M.V. "CLYDEFIELD"  
 PROPOSED ADDITIONAL FREEING PORT AREA

CLYDEFIELD

PROPOSED FREEING  
PORTS

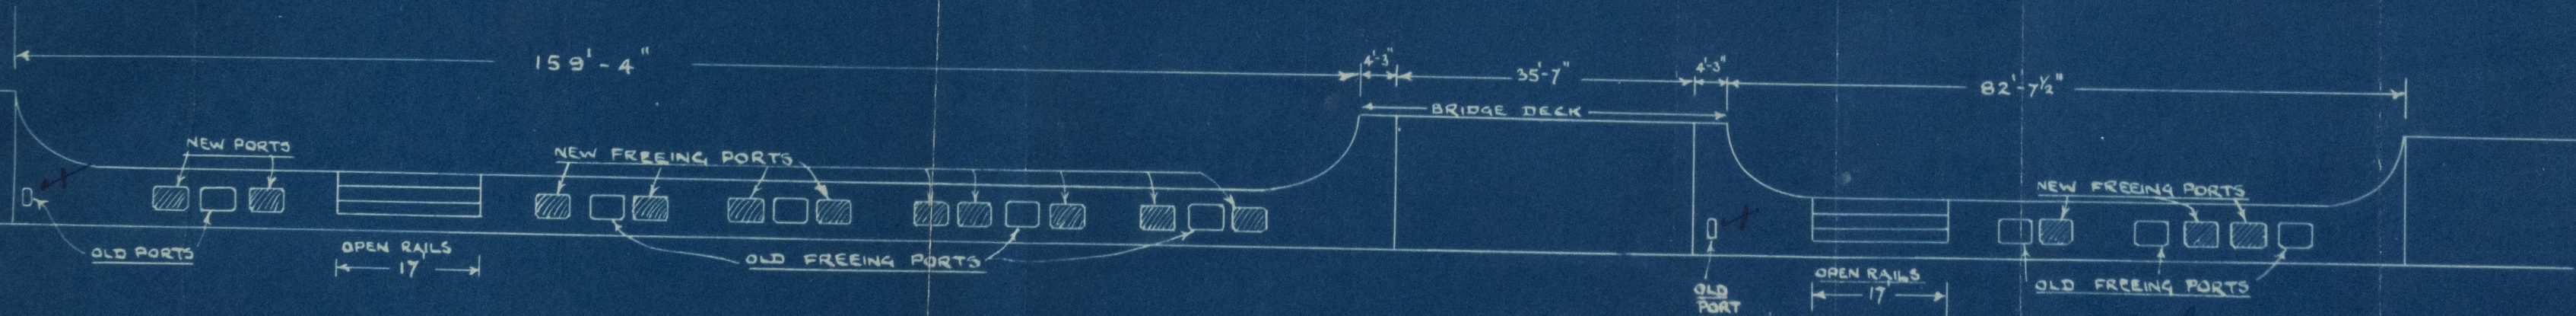
It is assumed that these are  
 freeing ports and not mooring pipes
